Docket Item #4
Development Site Plan #2023-00012 550
South Pickett Street
Avanti 550 Retail Building

Purpose of Application
The applicant requests approval of a Development Site Plan with modifications to construct a new retail building.
Applications/Special Use Permits/Modifications Requested:
Development Site Plan to construct a new retail building with a modification of the 50-foot setback from the centerline of South Pickett Street.

Staff Recommendation: APPROVAL WITH CONDITIONS
Staff Reviewers: Robert M. Kerns, AICP, Division Chief robert.kerns@alexandriava.gov Nathan Randall, Principal Planner nathan.randall@alexandriava.gov Leon Vignes, AICP, Urban Planner bert.vignes@alexandriava.gov

SOUTH PICKETT STREET CENTER LINE 50' SETBACK EXHIBIT
SCALE: 1" = 20'

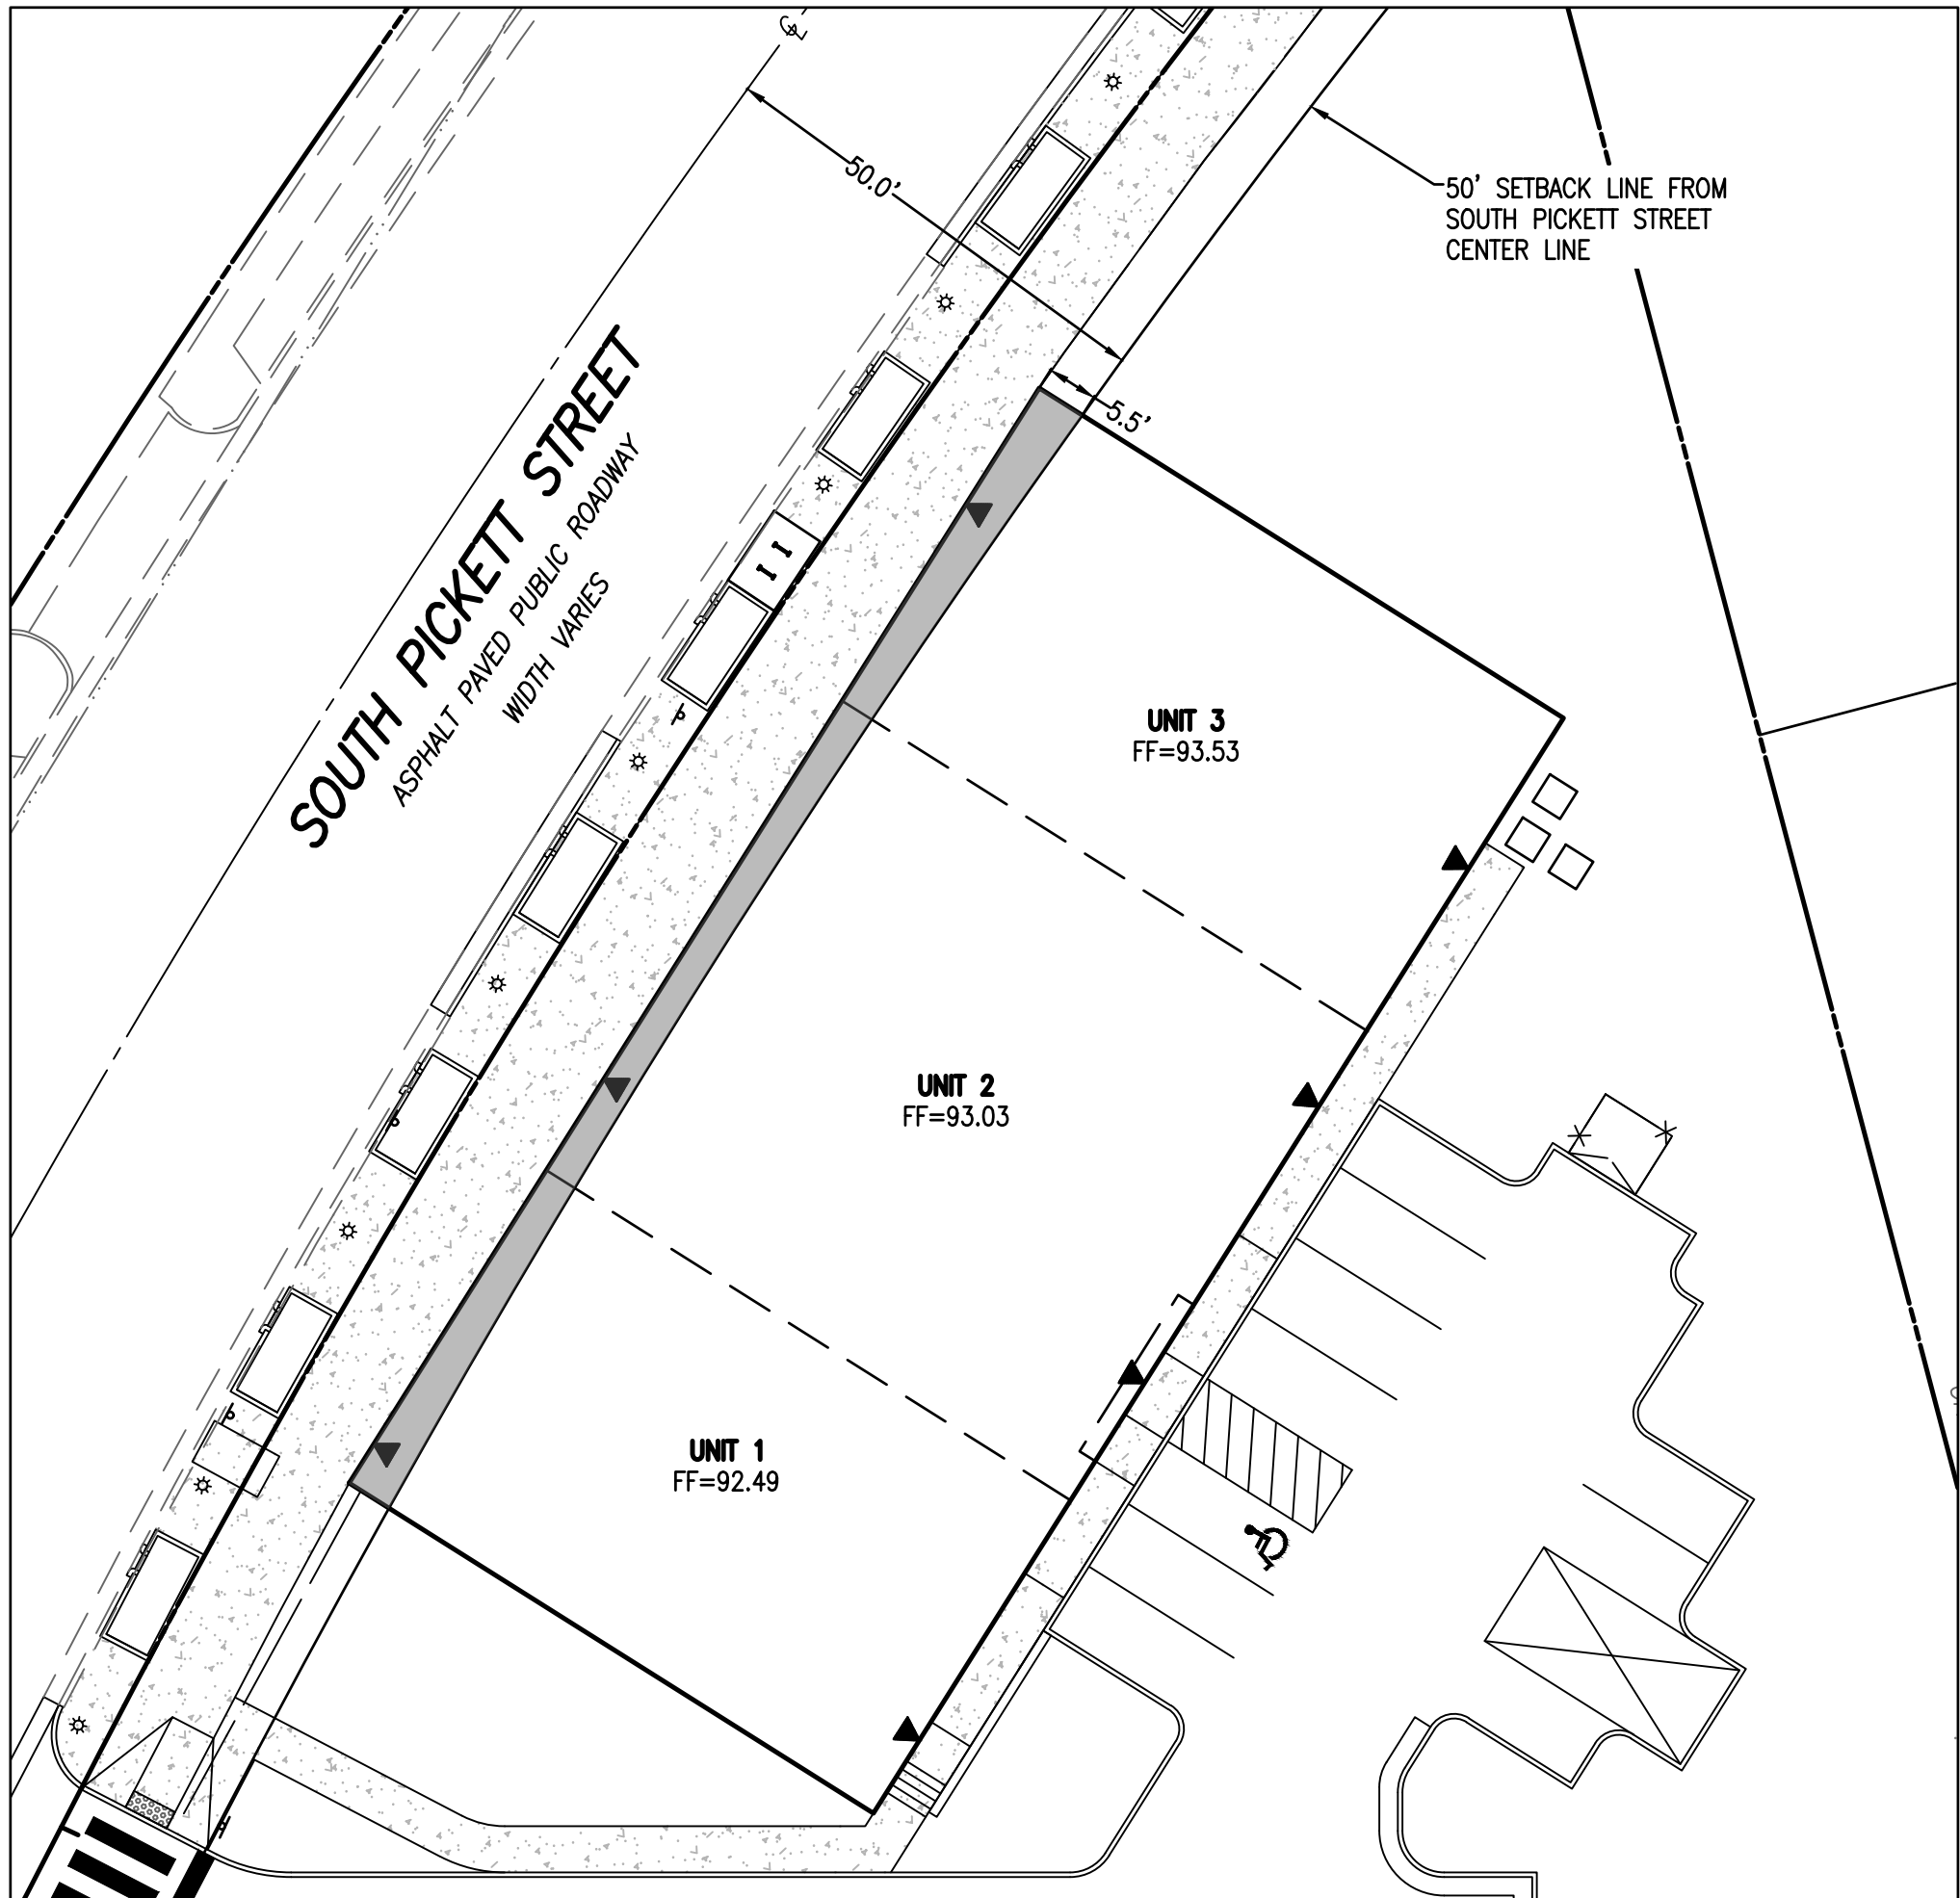
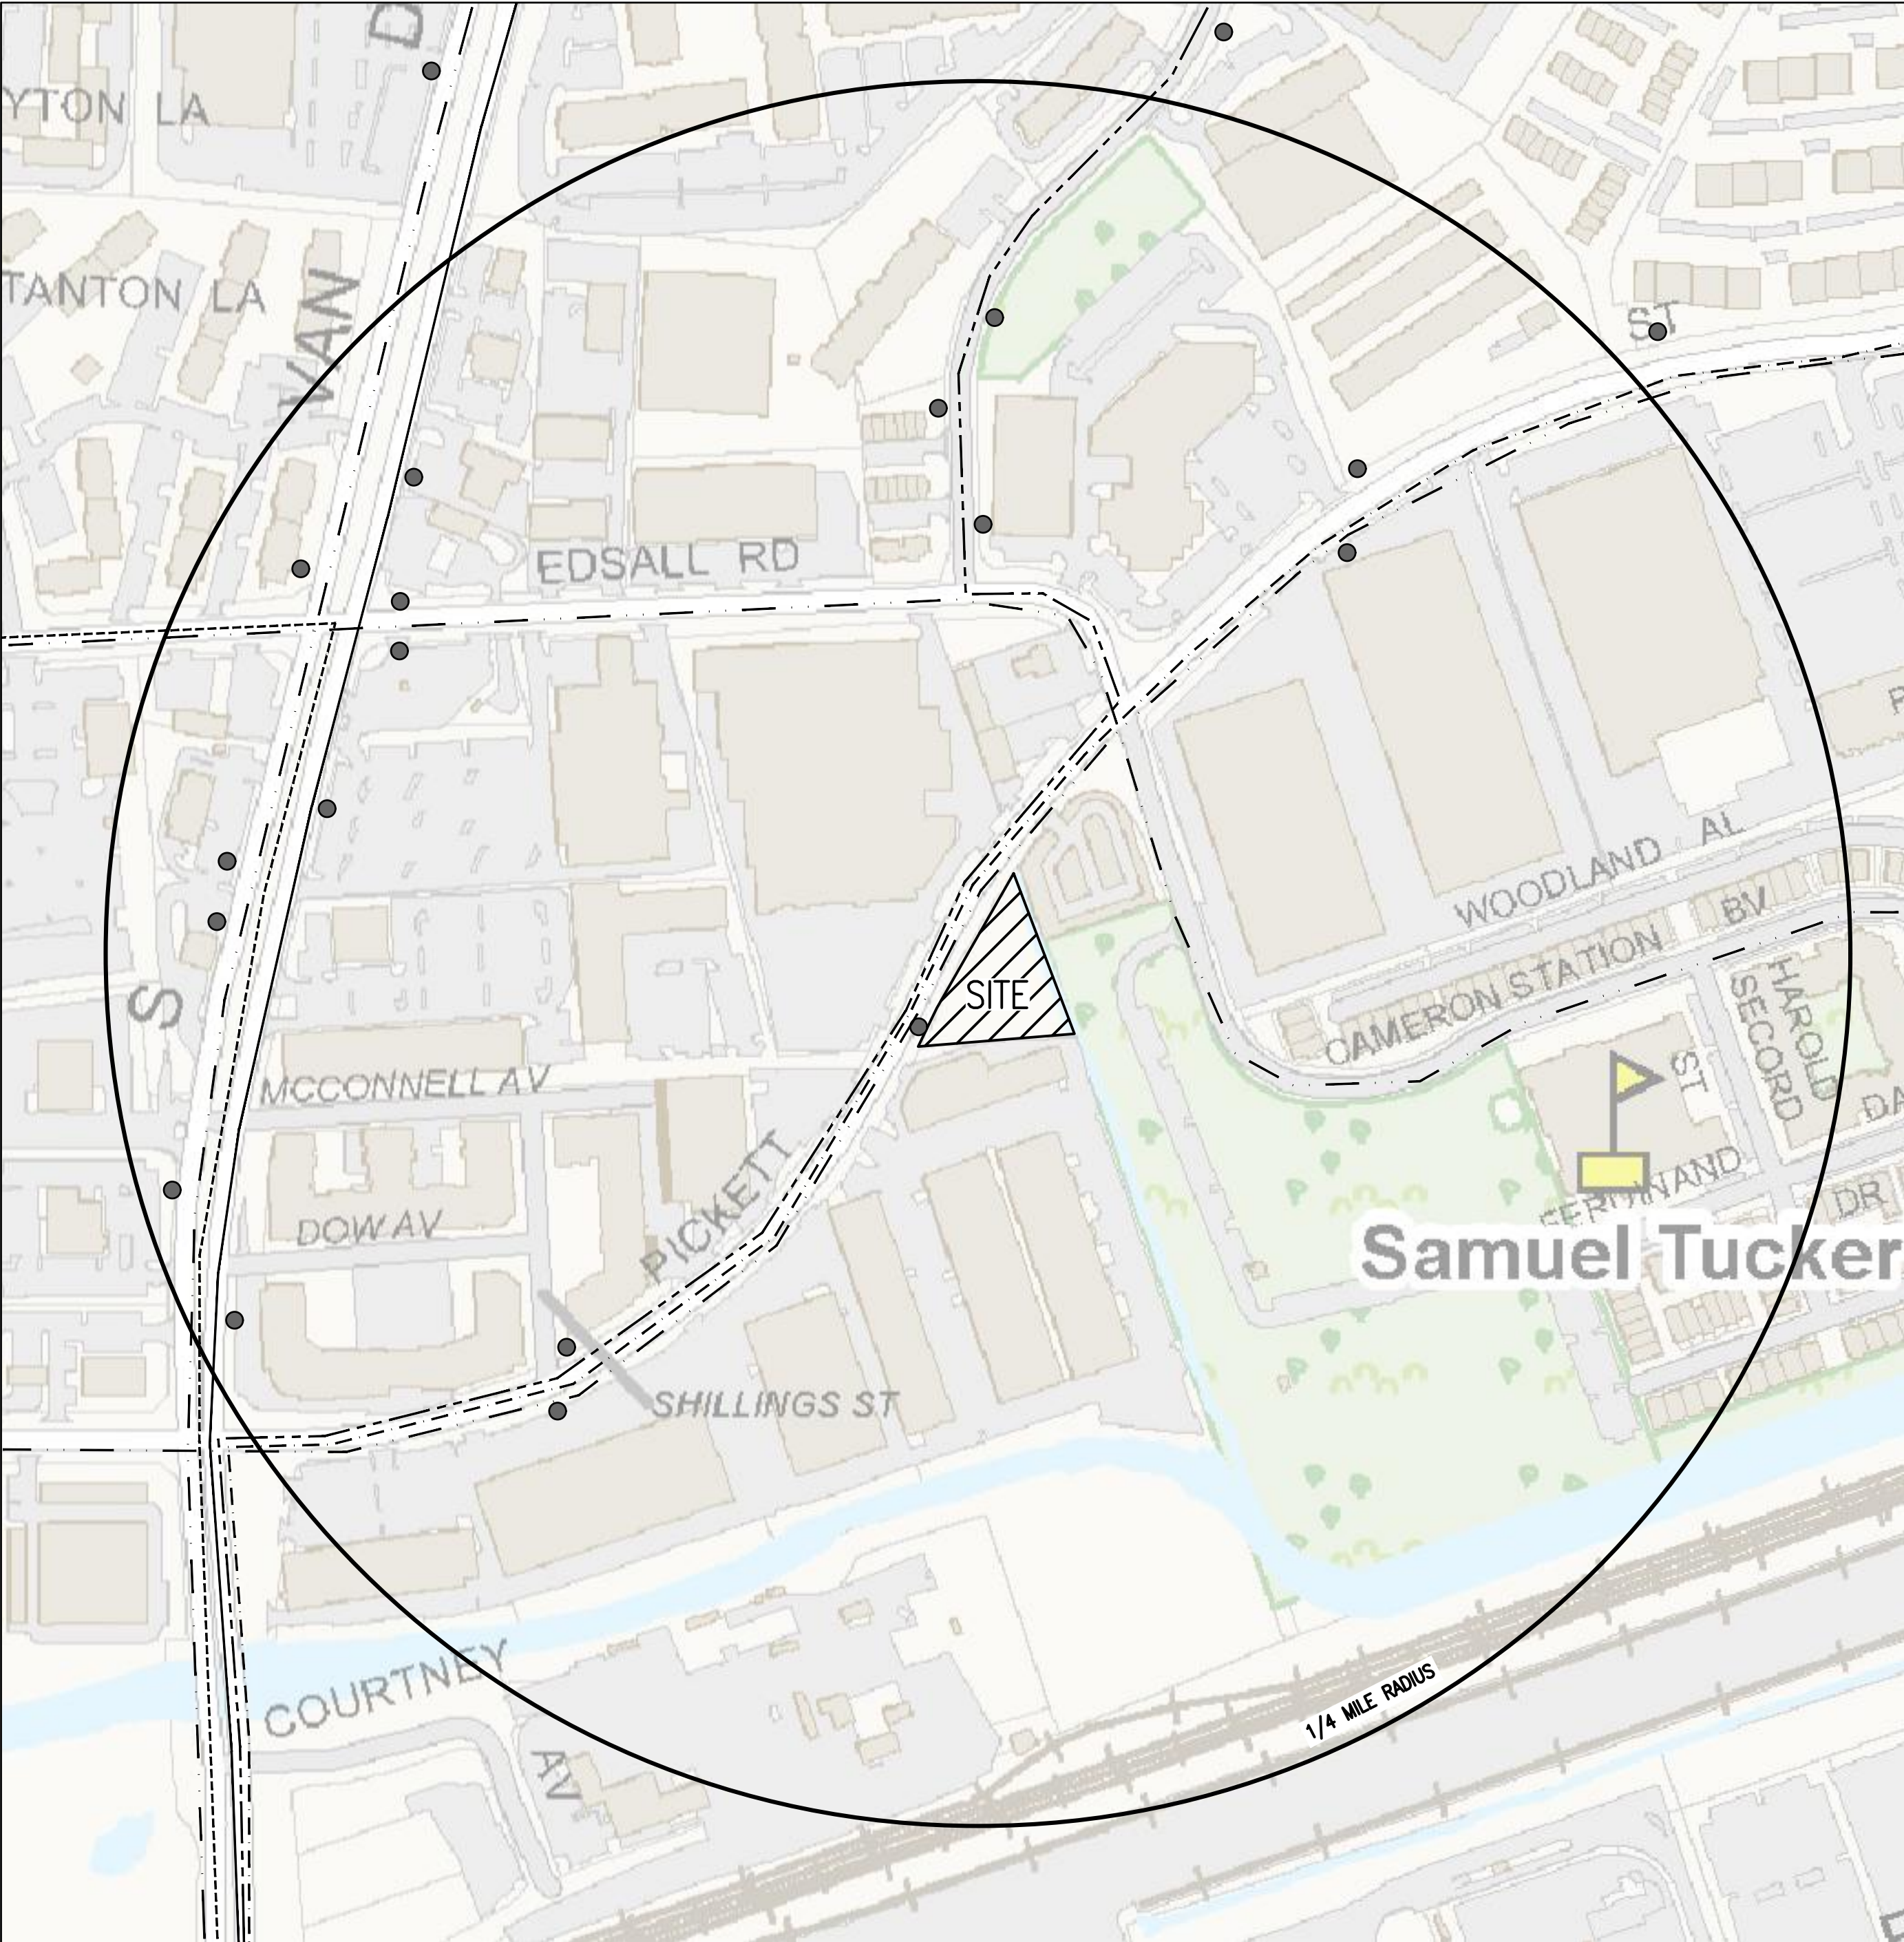
Comment 6: Cover Sheet and Sheet 2 – The Cover Sheet and the Section 6-403 exhibit (on Sheet 2) indicate that the building is setback 44.5 feet from the centerline of South Pickett Street. However, the “South Pickett Street 50-Foot Setback” exhibit shows the closest part of the building is located 44 feet from the setback instead of 44.5 feet. Ensure that these measurements are the same and correct any errors in the next submission.

Response: The dimensions have been updated to accurately show a setback of 44.5 feet. Please see sheet 2.
